Assessing new nuclear power
station designs

Generic design assessment of
Hitachi-GE's Advanced Boiling
Water Reactor

Assessment report - AR05
Aqueous Waste

December 2017

Figure 1. UK ABWR aqueous tritium normalised discharges compared to mean aqueous tritium normalised discharges (GBq/GWe.h) from similar plants worldwide (BWRs and ABWRs) 2005 to 2013

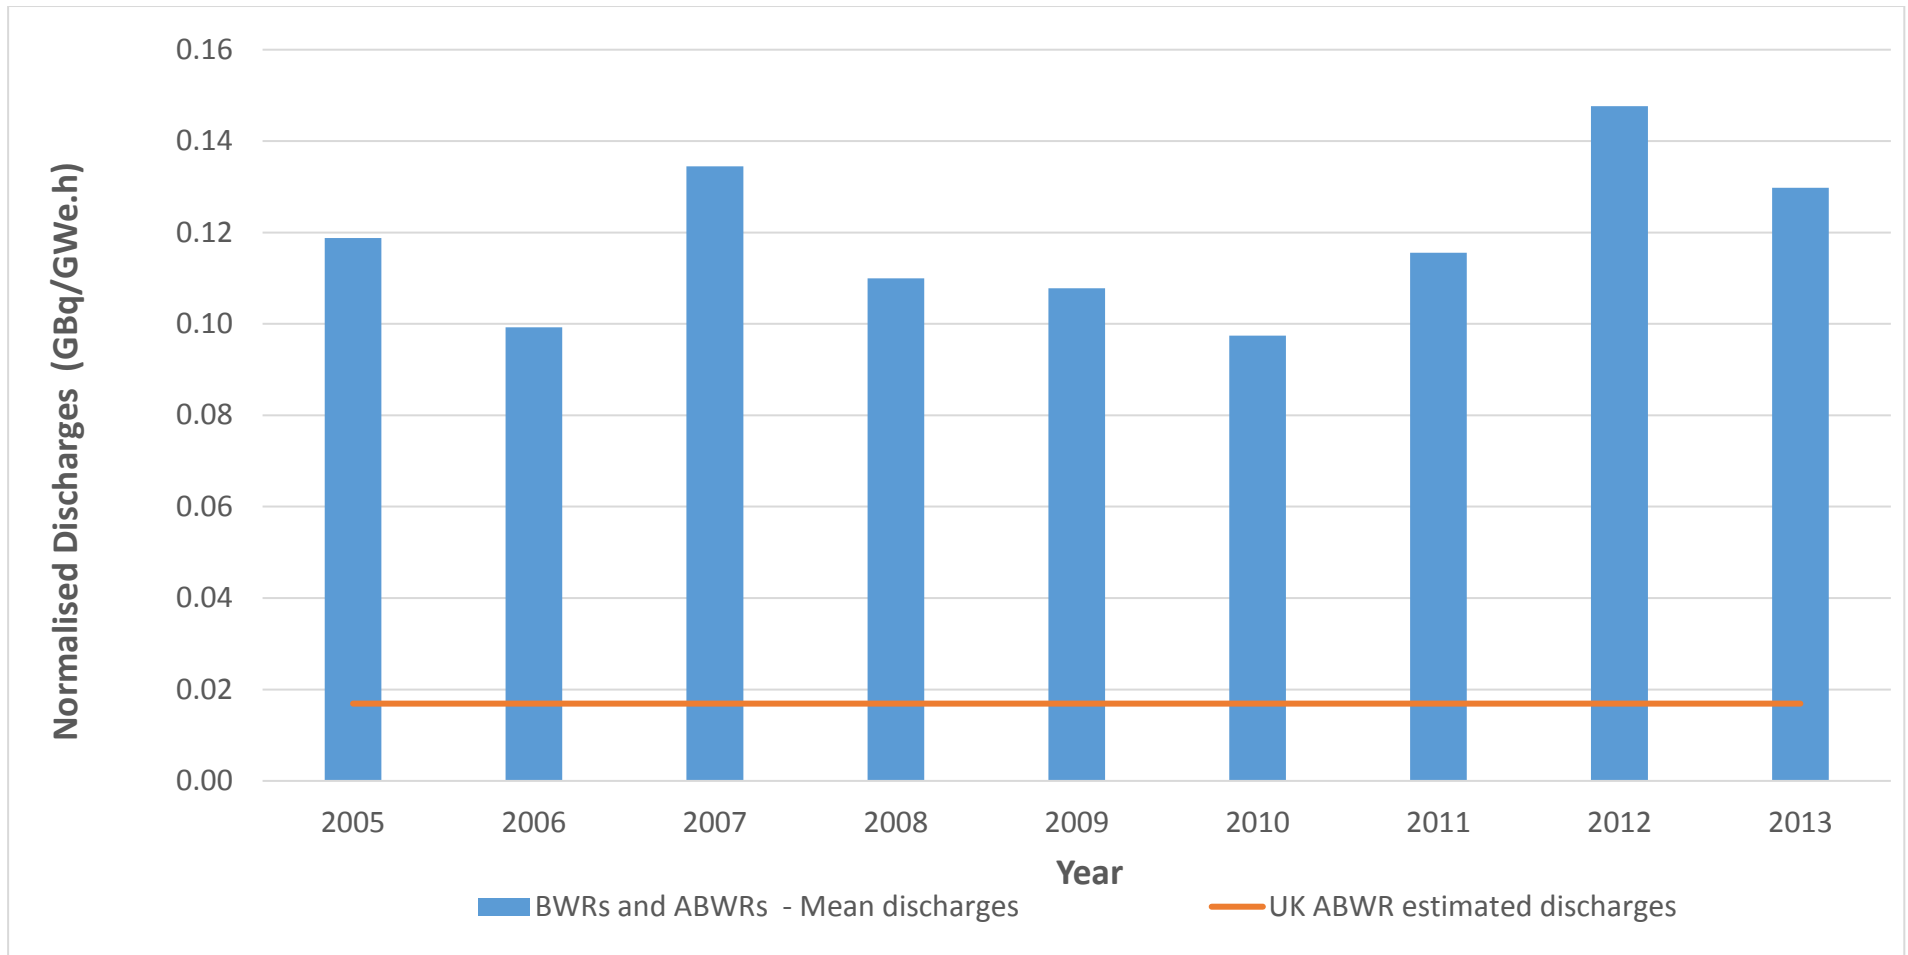
Tritium discharges, normalised for power output, from comparable reactors (BWRs and ABWRs) were taken from our report of discharges from existing BWRs and ABWRs (Environment Agency, 2016b). The mean discharges (normalised to power output) (Table 4) were compared to those estimated from the UK ABWR, also normalised for predicted energy output (Figure 1). It can be seen that for tritium, the predominant nuclide in aqueous discharges, the UK ABWR estimated discharges are well below those from existing comparable reactors.

Figure 2. UK ABWR aqueous normalised discharges (GBq/GWe.h) for other beta-gamma compared to mean aqueous other normalised discharges (GBq/GWe.h) from similar plants worldwide (BWRs and ABWRs) 2005 to 2013

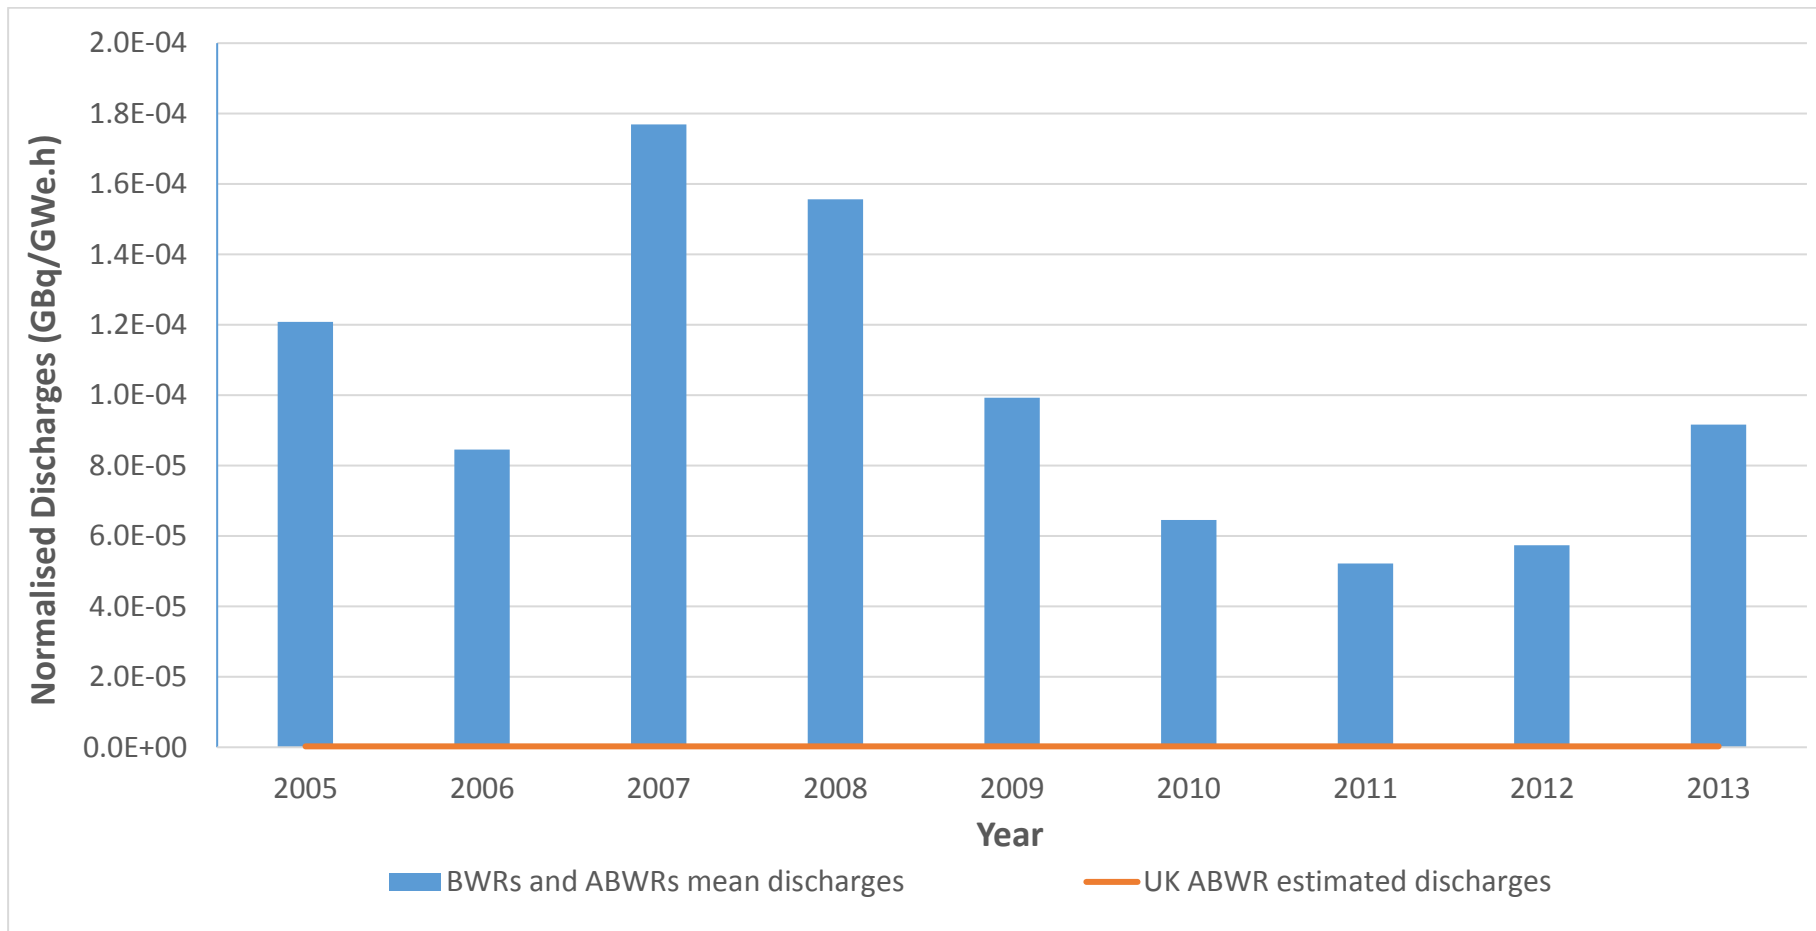
Other beta/gamma discharges, normalised for power output, from comparable reactors, BWRs and ABWRs, were taken from our report of discharges from existing BWRs and ABWRs (Environment Agency, 2016b). The mean discharges (normalised to power output) were compared to those estimated from the UK ABWR, also normalised for energy output (Figure 2). It can be seen that for other beta gamma activity in aqueous discharges, the UK ABWR estimated discharges are well below those we see from existing comparable reactors.
